Service Manual

CD Stereo System

Model No. **SA-AKX74PH**
SA-AKX74PN
SA-AKX94PH
SA-AKX74PR
SA-AKX94PR

Subject : Updates on Block Diagram, Schematic Diagram, Printed Circuit Board, Exploded View & Parts List.

SA-AKX74PH/PN POWER SUPPLY (1/2) BLOCK DIAGRAM

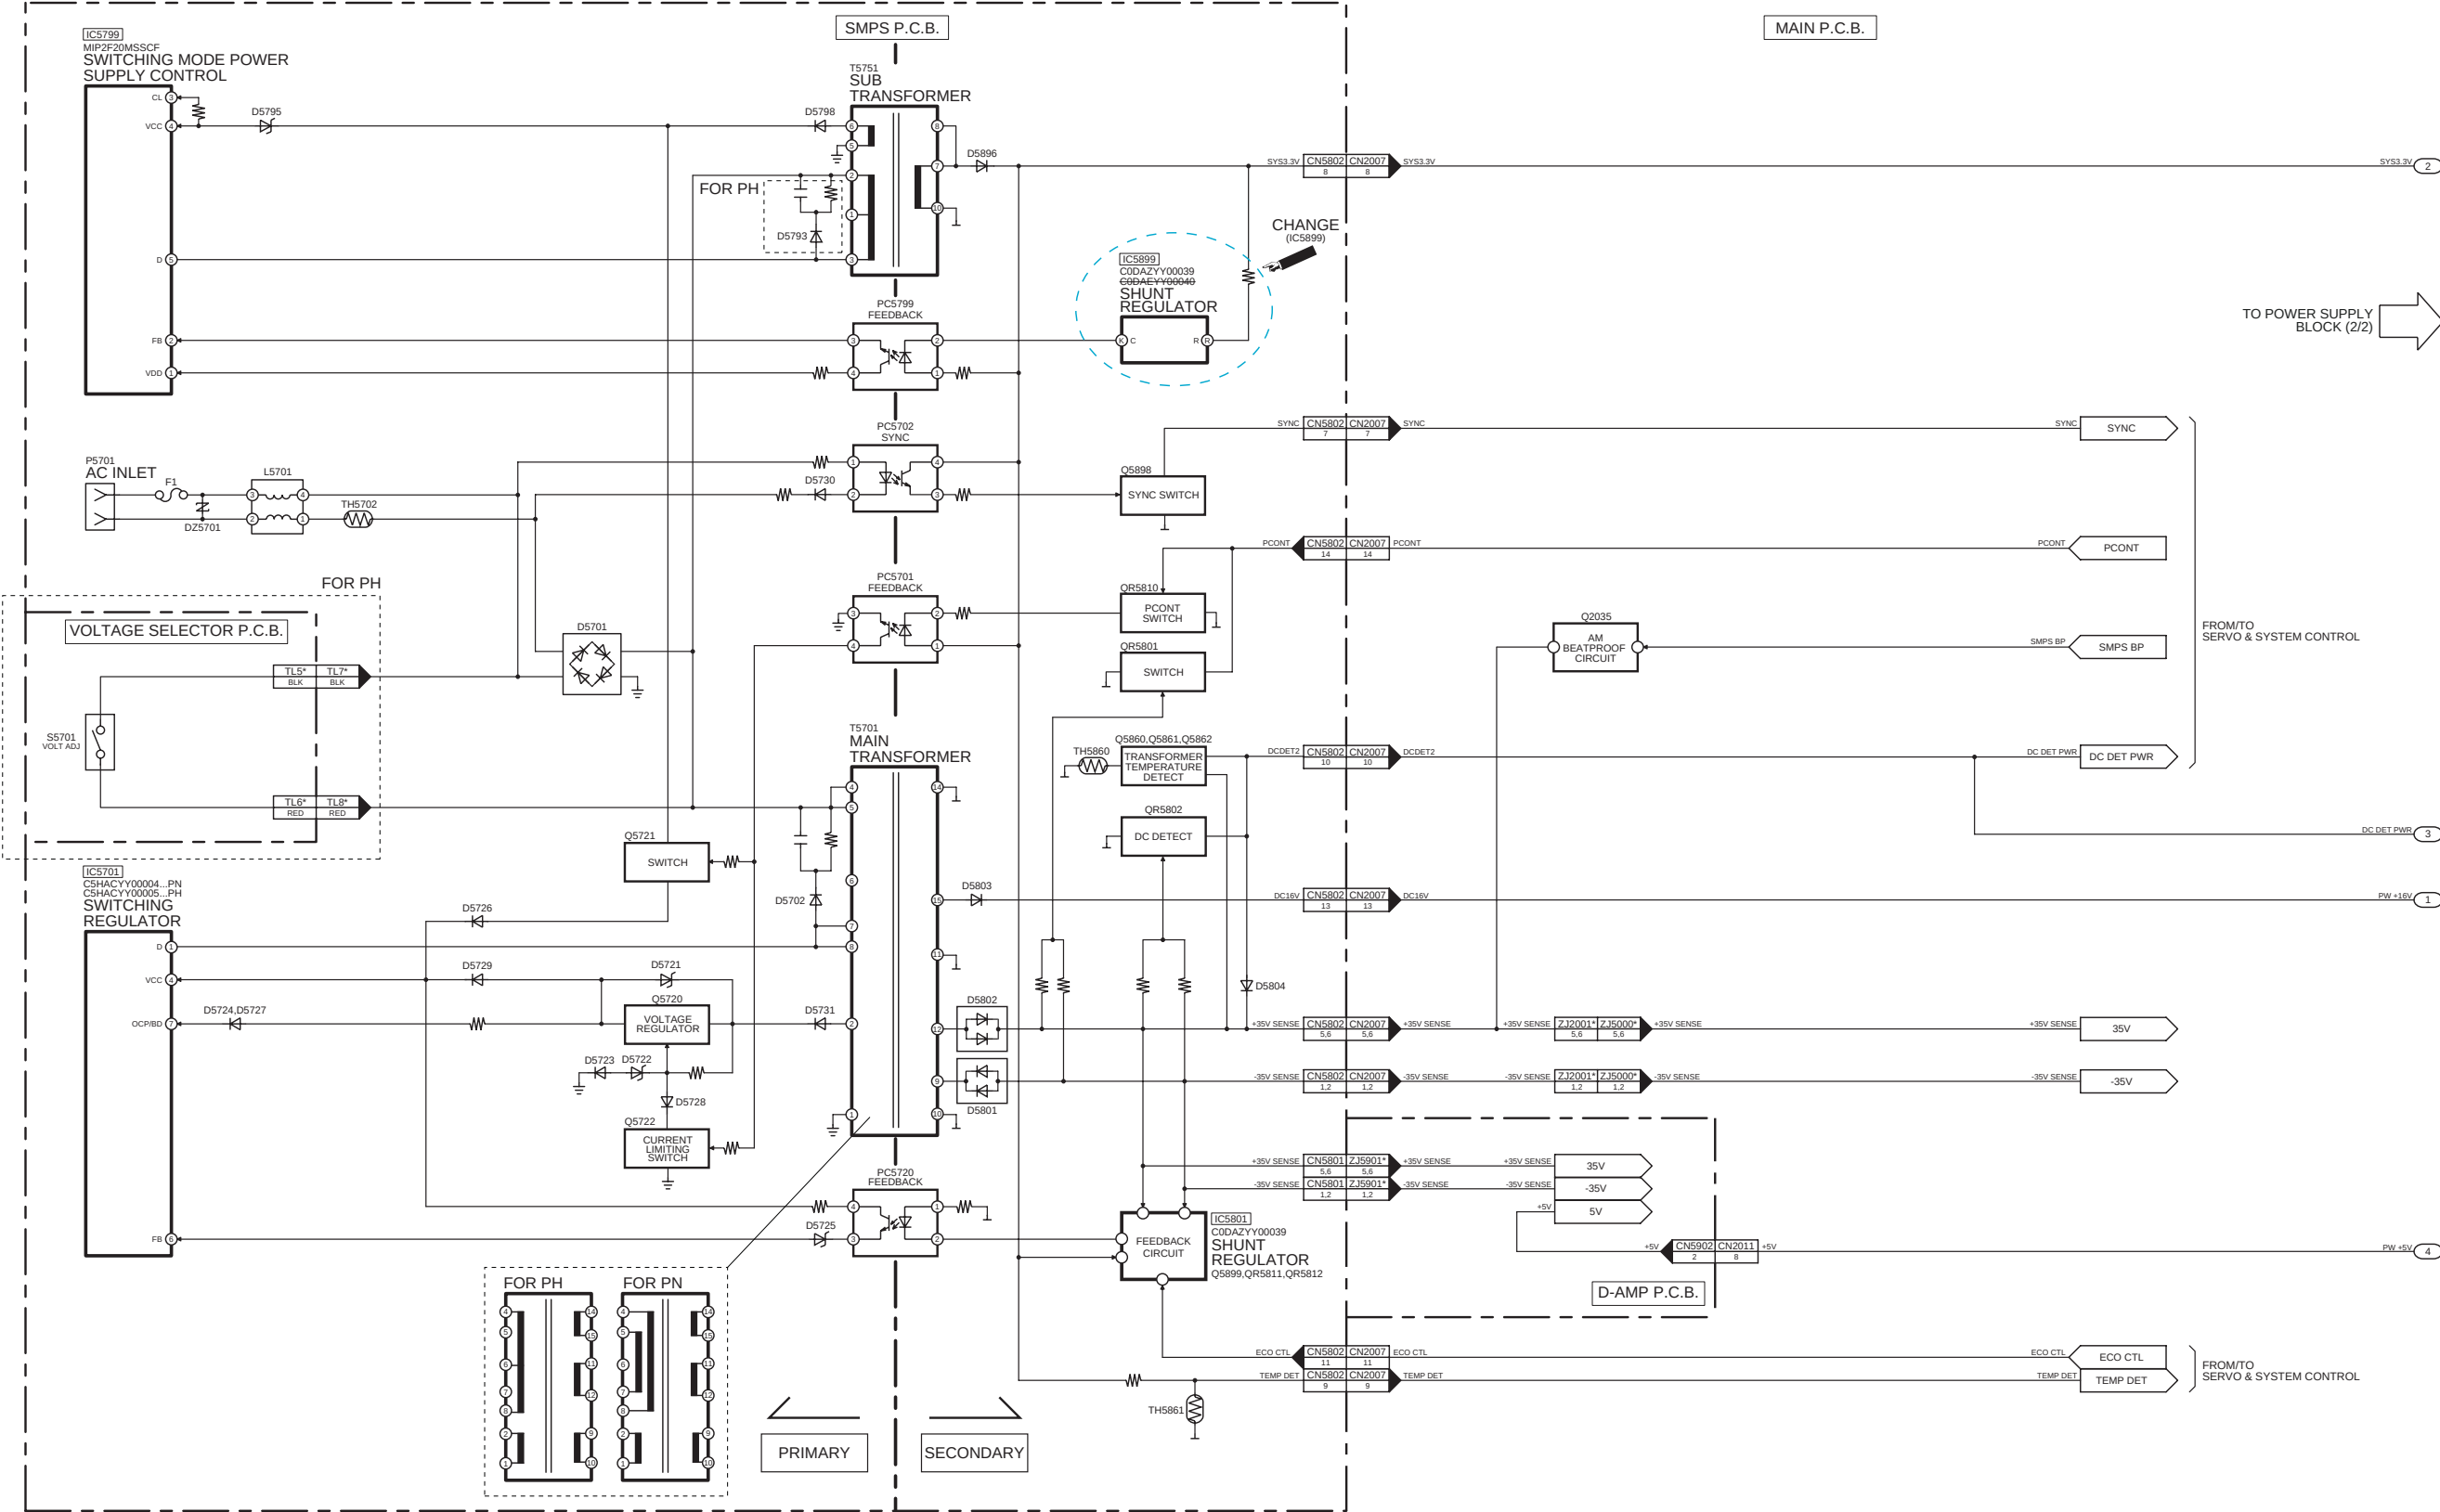
With reference to original service manual (section 14.4) on pages 77.

SA-AKX94PH POWER SUPPLY (1/2) BLOCK DIAGRAM

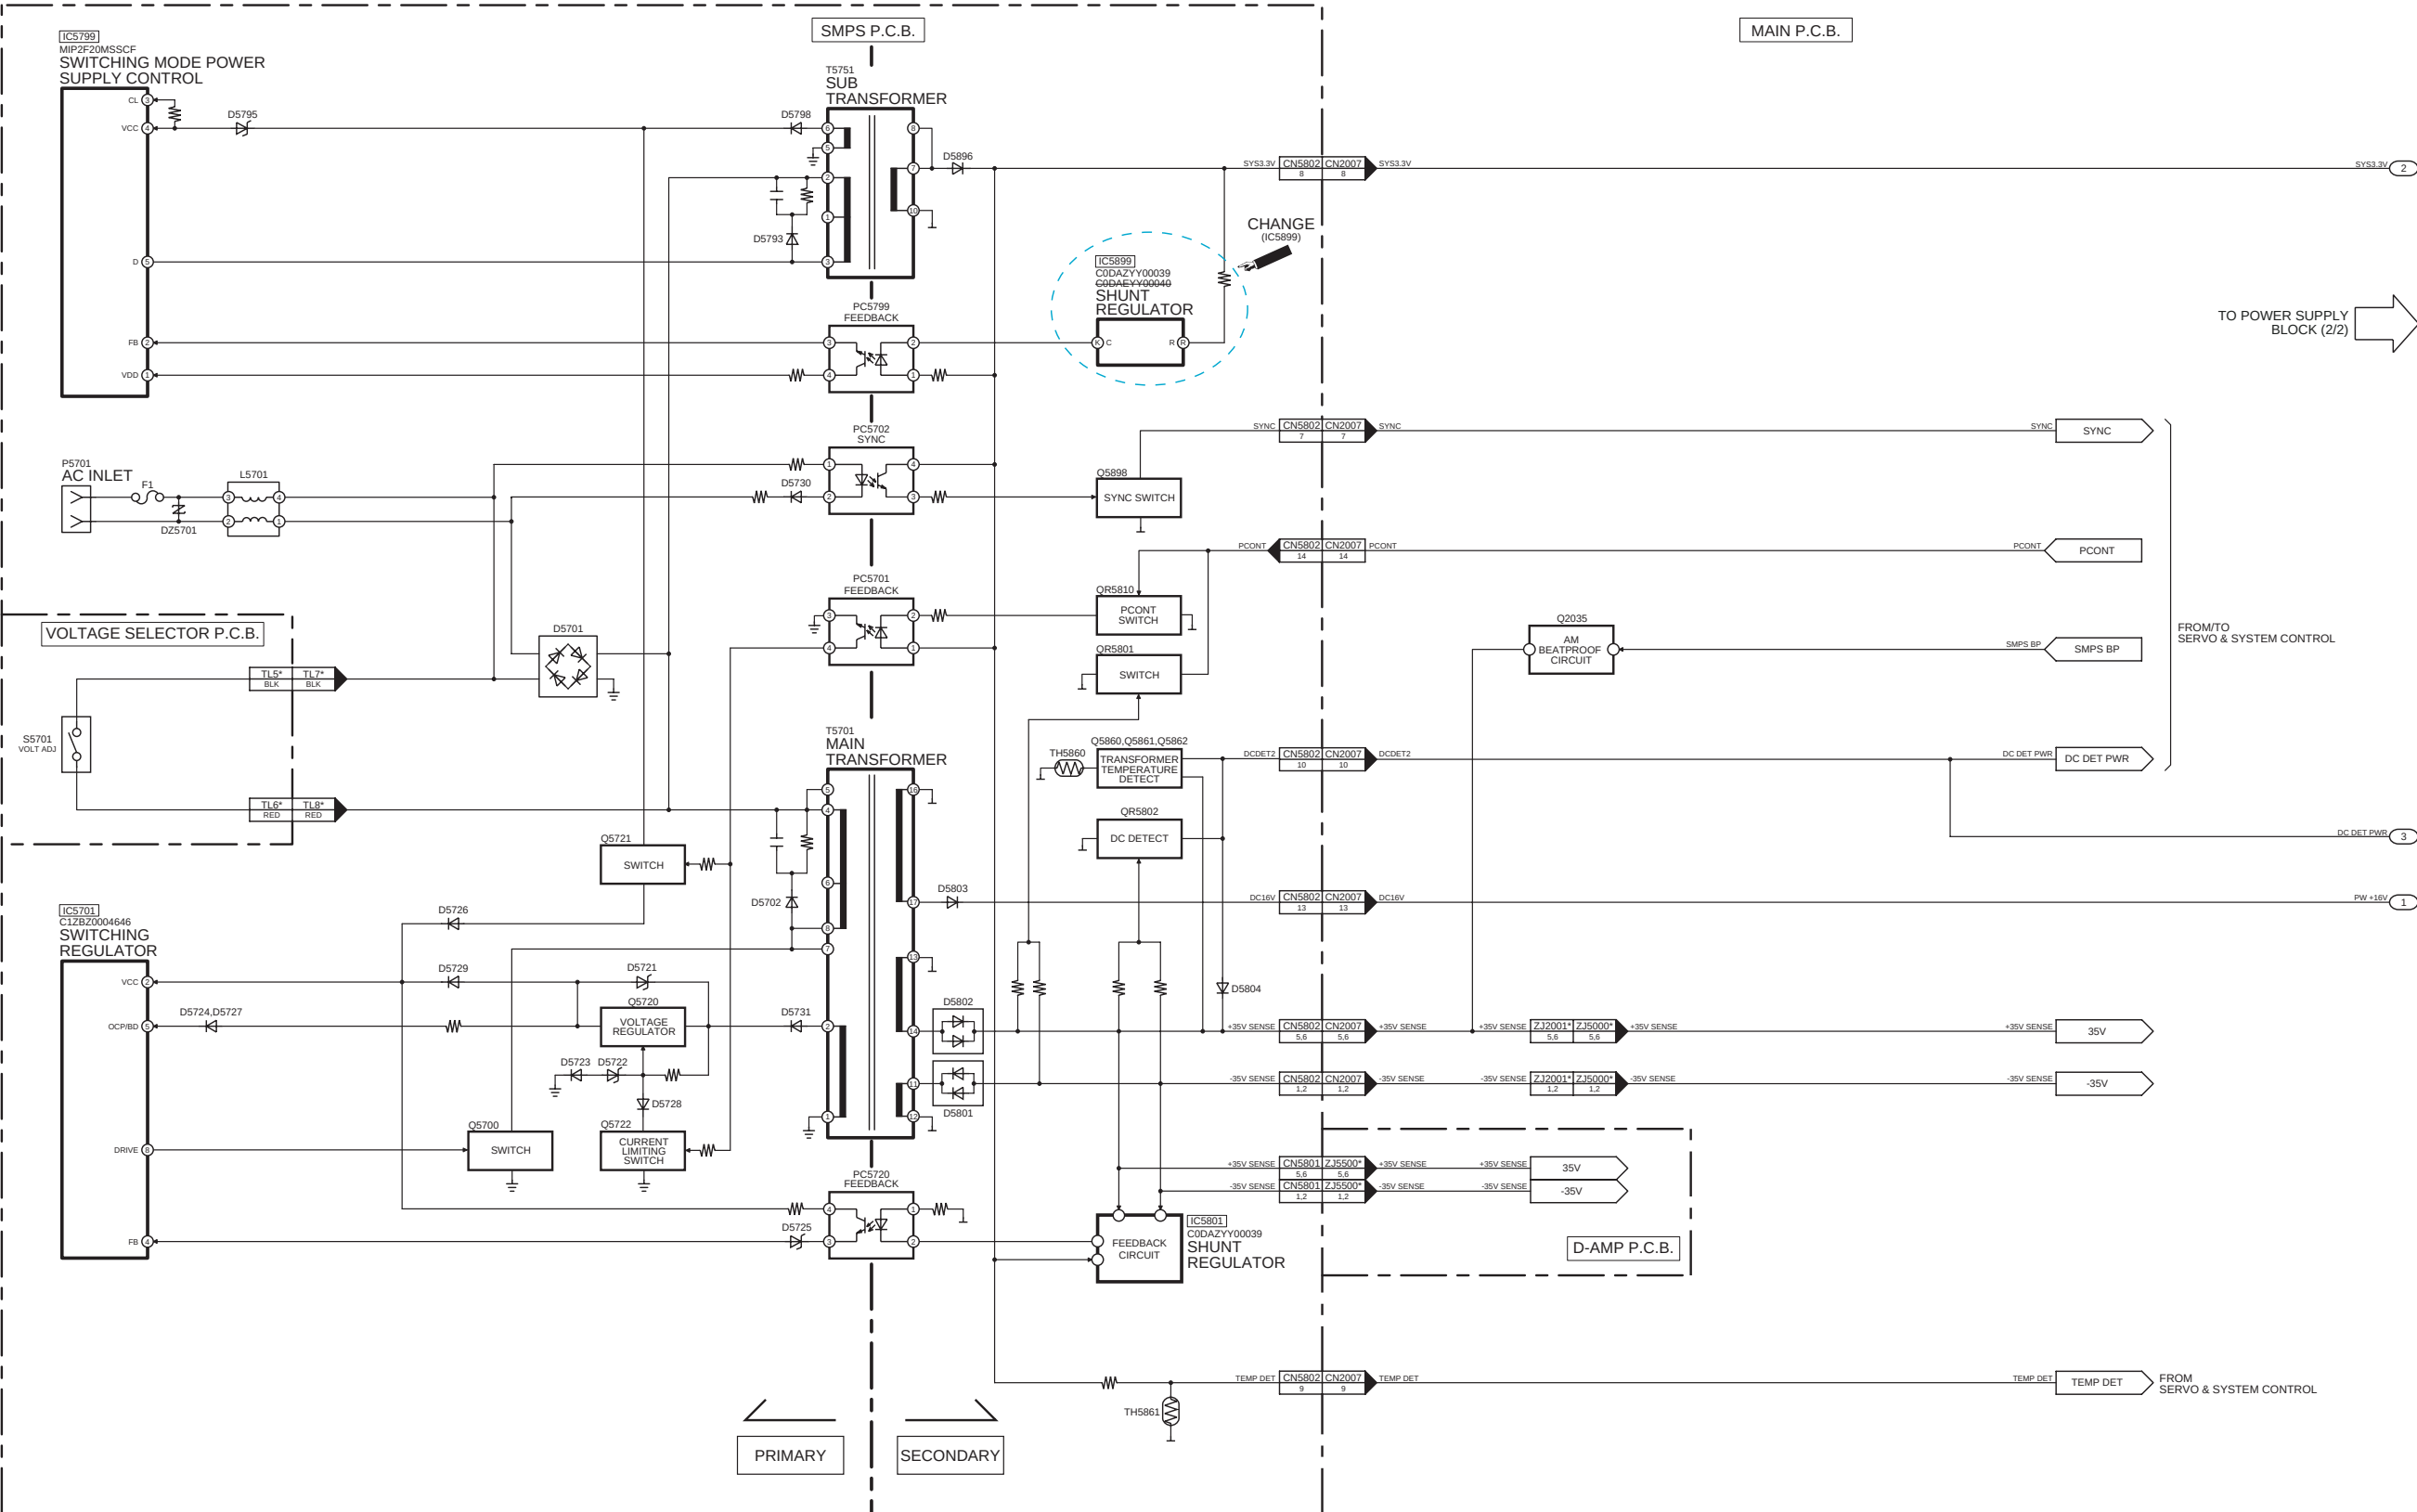
With reference to original service manual (section 14.4) on pages 81.

3.2. Panel Circuit (SA-AKX74PH/PN-K)

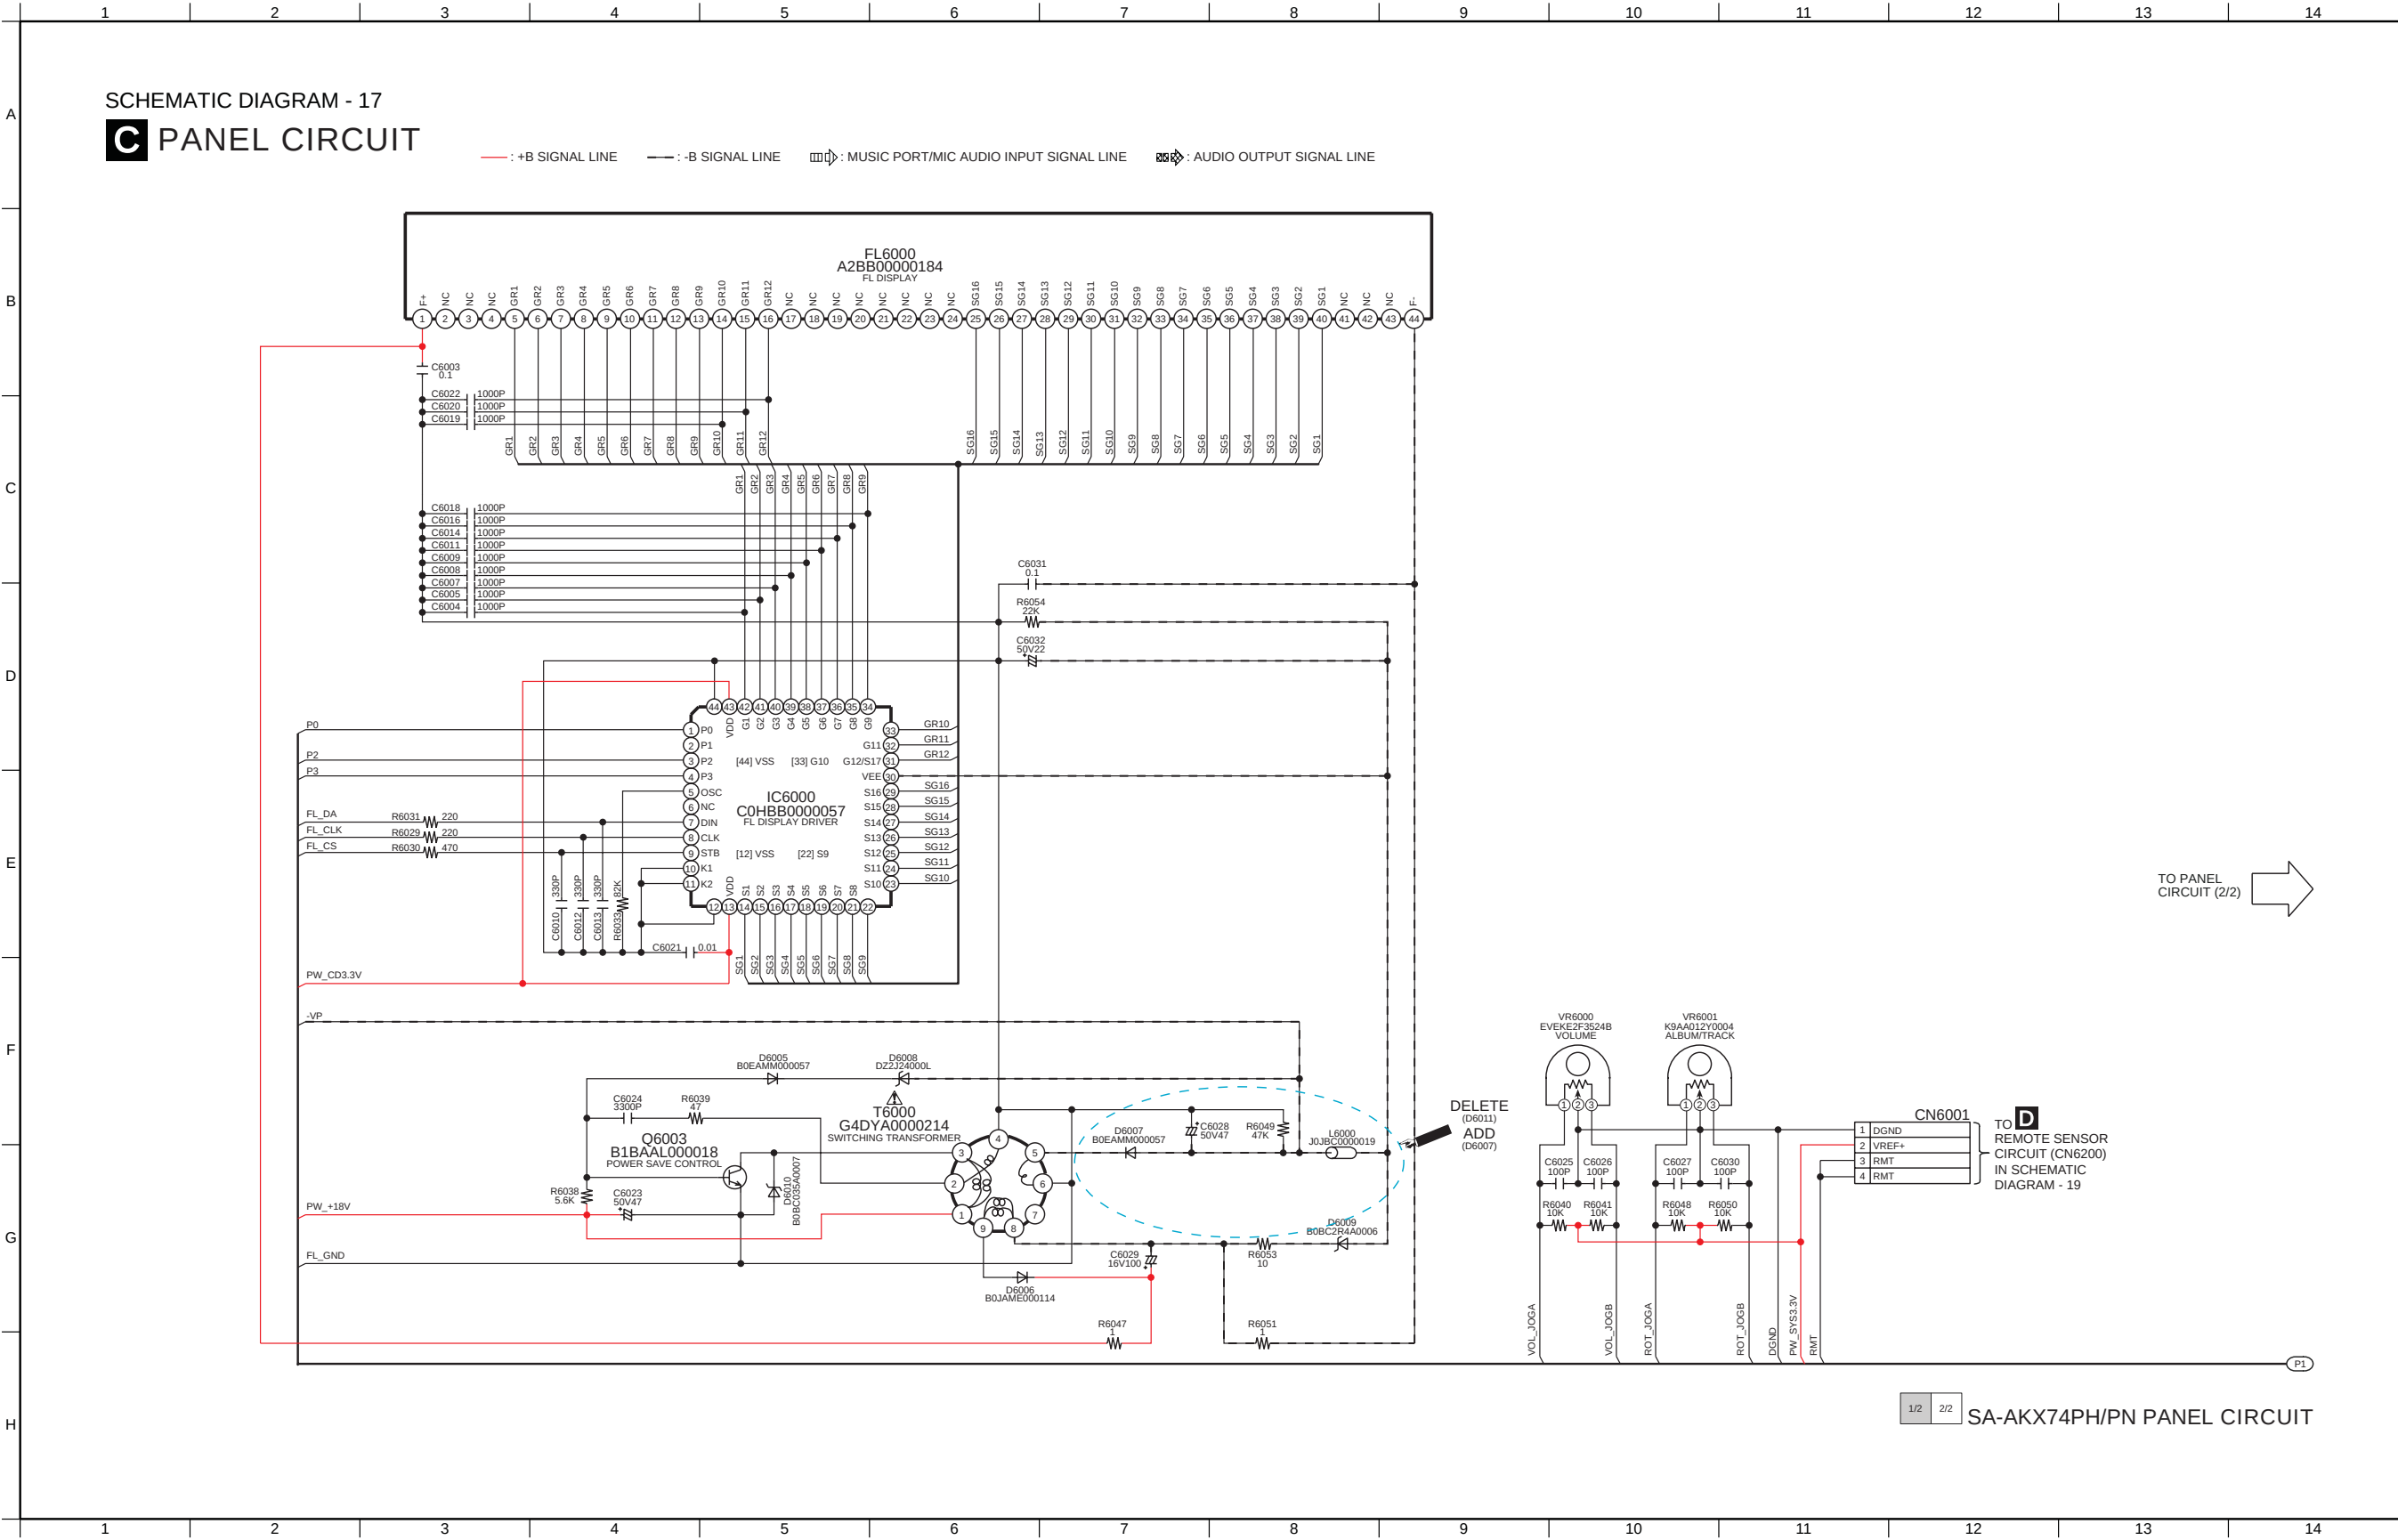
With reference to original service manual (section 16.5) on pages 99.
